# UNITED STATES PATENT AND TRADEMARK OFFICE

| APPLICATION NO.   | FILING DATE | FIRST NAMED INVENTOR | ATTORNEY DOCKET NO.   | CONFIRMATION NO. |
|---|-------------|----------------------|-----------------------|------------------|
| 10/820,134  | 04/08/2004  | Han Jun Sung         | 1594.1364             | 6666             |

| <b>Office Action Summary</b> | <b>Application No.</b><br>10/820,134 | <b>Applicant(s)</b><br>SUNG ET AL. |  |

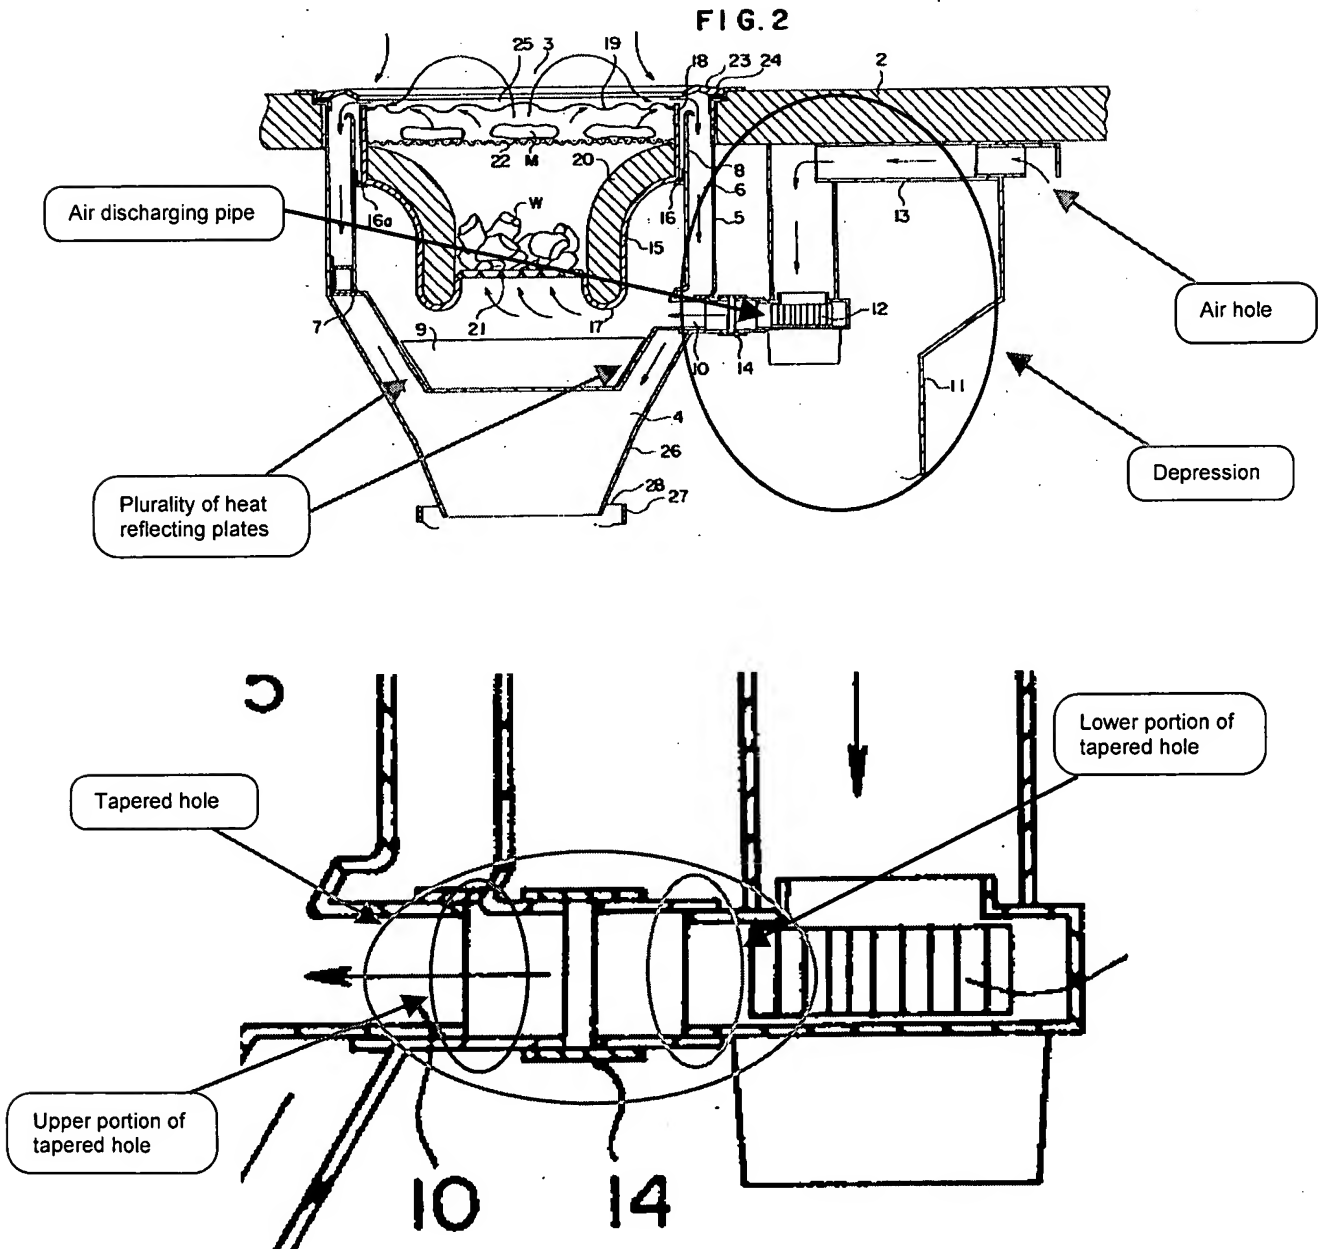
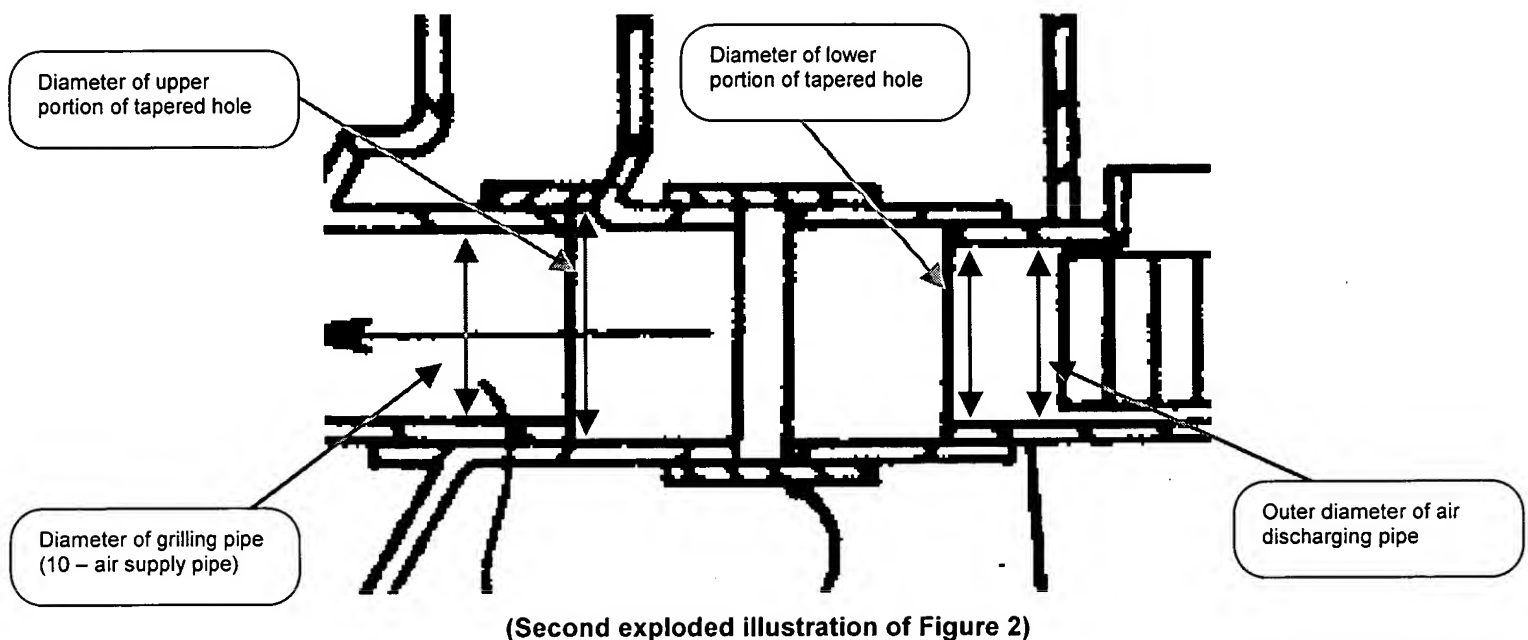
- the grilling pipe has an inlet at one end and an outlet at another end thereof (as seen in Figure 2);
- an air discharging pipe (as seen in the illustration of Figure 2 below) to connect the blowing fan to the inlet of the grilling pipe, the air entering the grilling pipe by the blowing fan blowing air into the air discharging pipe and being discharged to an area outside of the grilling pipe through the outlet of the grilling pipe (as seen in Figure 2);

- the connection member comprises a tapered hole (as seen in the first exploded illustration of Figure 2 below) that is tapered in a direction from a top to a bottom of the connection member, the inlet of the grilling pipe being connected to an upper portion of the tapered hole (as seen in the first exploded illustration of Figure 2 below), and the air discharging pipe being connected to a lower portion of the tapered hole (as seen in the first exploded illustration of Figure 2 below) to allow the grilling pipe to be removably connected to the air discharging pipe using the connection member (inherent);

- a grease collecting unit (9 – dust pan), provided in the cabinet under the grilling unit (as seen in Figure 2);
- the heating unit comprises a plurality of heating units (there is a plurality of charcoal pieces) that are respectively arranged on opposite side surfaces of the cabinet (as seen in Figure 2), and the grease collecting unit comprises a plurality of heat reflecting plates that face the heating units (as seen in the illustration of Figure 2 below);

- the upper portion of the tapered hole has a diameter greater than an outer diameter of the grilling pipe (as seen in the second exploded illustration of Figure 2 below), the lower portion of the tapered hole has a diameter less

than the outer diameter of the grilling pipe (as seen in the second exploded illustration of Figure 2 below), and the diameter of the lower portion of the tapered hole is approximately equal to an outer diameter of the air discharging pipe (as seen in the second exploded illustration of Figure 2 below);

- an air discharging pipe (as seen in the first exploded illustration of Figure 2 above) to connect the blowing fan to the inlet of the grilling pipe, with air entering the grilling pipe by both the blowing fan and the air discharging pipe, and then being discharged to an outside of

- a connection member (14 – connecting pipe) provided on an upper portion of the cabinet to connect the air discharging pipe to the inlet of the grilling pipe (as seen in Figure 2), the connection member having a tapered hole (as seen in the first exploded illustration of Figure 2 above) that is tapered in a direction from a top to a bottom of the connection member, with the inlet of the grilling pipe being connected to an upper portion of the tapered hole (as seen in the first exploded illustration of Figure 2 above), and the air discharging pipe being connected to a lower portion of the tapered hole (as seen in the first exploded illustration of Figure 2 above) to allow the grilling pipe to be removably connected to the air discharging pipe using the connection member (inherent);

- a depression (as seen in the illustration of Figure 2 above) on a lower surface of the recess to receive the air cooling unit of the grill cooker, with an air hole (as seen in the illustration of Figure 2 above) on a surface of the depression to draw air into the air cooling unit to allow the grilling unit to be cooled by the air when the grill cooker is set in the recess, the air cooling unit being received in the depression (as seen in Figure 2);
